Technical & Safety Information Notice No.	02/2011 MarS Ripcord Handle Pins W.N. 37
Date of Issue	24 February 2011 - Note – while the MarS Service Bulletin is dated September 10 <sup>th</sup> 2010, it was received by the T&S Committee on 24 February 2011.
Subject Matter and Applicability	MarS a.s., Okružní II. čp. 239, 569 43 Jevíčko BULLETIN CZECH REPUBLIC C+M
	SERVICE BULLETIN No. 11/09/2010
	Check of Ripcord Handle Pins

SERVICE BULLETIN

Attachment no. 1

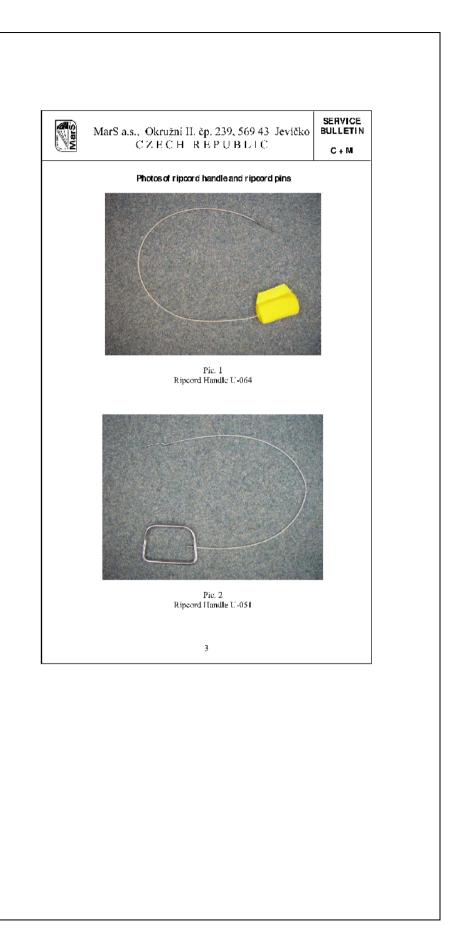
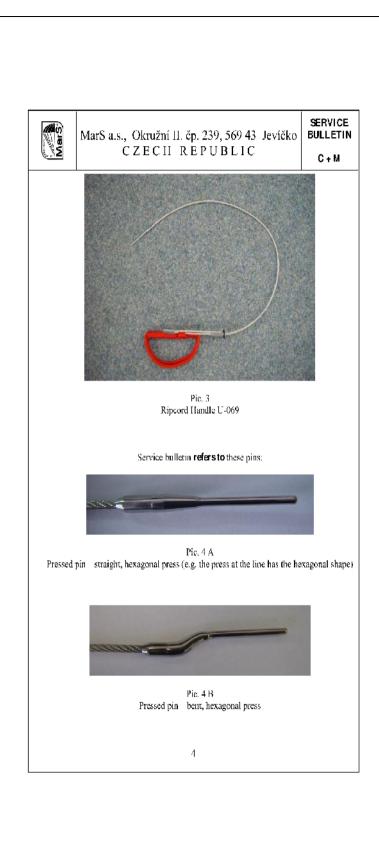
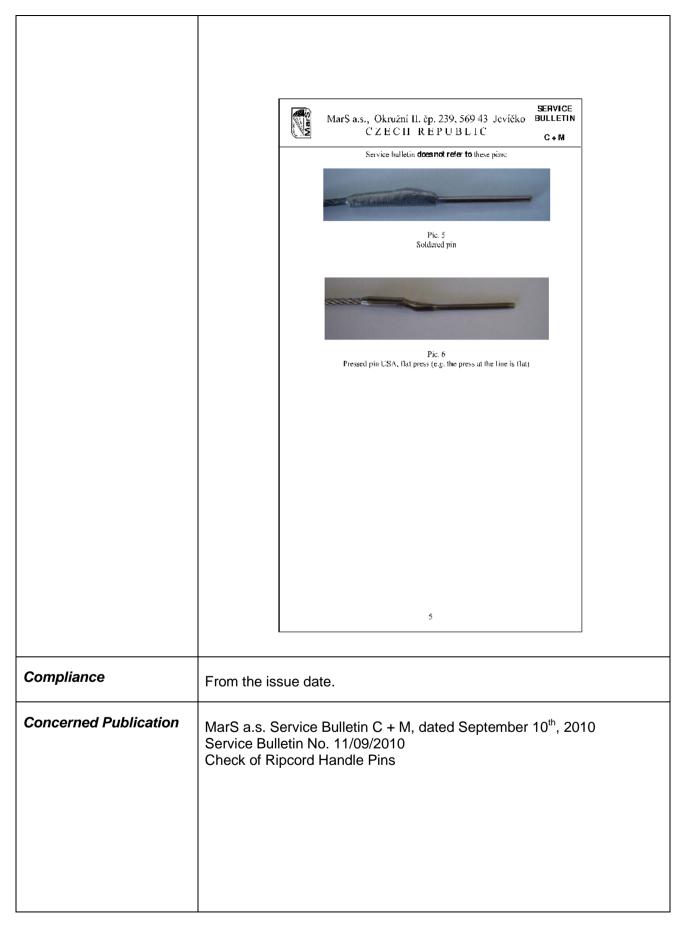
1. APPLIESTO: the pins of ripcord handle reserve parachutes U = 064 ( pic.1), U = 051 ( pic.2) and U = 069 ( pic.3), produced by Synck company ( pressed pins = hexagonal press, see pic. 4 A - straight and pic. 4 B = bently, which are parts of: Parachute sets Real = X, OP-103/PS-034 S (U = 051) OP-103/PS-034 S (U = 051) OP-103/PS-035 (U = 064) Containers of parachutes with harness OP-087/PS-034 S (U = 051) OP-087/PS-034 U (U = 064 or U = 051) OP-087/PS-034 U (U = 064 or U = 051) OP-087/PS-034 U (U = 064) OP-087/PS-034 U (U = 064) OP-093/01/PS-034 S (U = 051), and Parachute sets MarS = T, OP-095T/PS-052T(1 = 069), delivered by MarS a.s. Jevíčko, used in civil aviation, and further Parachute sets M 282 a M 291 (U = 051). and Parachute sets PPSO CZ 330(HOP 330) (U = 069), delivered by MarS a.s. Jevíčko, used in military aviation.  2. REASON: During multiple tests for attestation of power for tearing off the ripcord handle it was found out gradual increase of the power beyond the permissible range that is defined by the regulation (22,2 to 97,9 N). During analysis of this situation it was found out that during the multiple tearing-off the ripcord handle the surface of the ripcord pin body can be damaged. This state can further cause an increase of power needed for tearing off the ripcord handle.

<ul> <li>3. MEASURES: - A user or a packer licensed to pack the reserve parachuses (authorized person) proceeds a check of the ripcord handle pin at the products mentioned in part 1 and in case the pin body is found damaged, he/she puts the parachute set out of service.</li> <li>- Further he/she sends a report with the type number of the ripcord handle and also the length of the ripcord handle at the type U-064 and U-051 to MarS a.s. Jevičko to the fax number + 420 461 353 861 or to an E-mail mars/marsjev.ez.</li> <li>- The producer sends the new ripcord handle to the user free of charge.</li> <li>- The user sends the original part of the ripcord handle back to the producer.</li> <li>- In case there is also excessive damage on the flap grommet, which is placed under the ripcord handle pin body during packing, the user send-the container of the parachute with harness and with</li> </ul>

WARNING:
The above mentioned provisions do not refer to the releases
U = 064, U = 061, U = 069, produced with pins in types:
- soldered, see pic. 5
- pressed USA (flat press), see pic. 6.

the ripcord handle reserve parachute, or the whole parachute set back to the MarS a.s. Jevičko for the examination.

- MarS a.s. Jevičko proceeds professional check of the state of the ripcord handle pin and the grommet and based on the results of the examination they exchange the parts concerned.
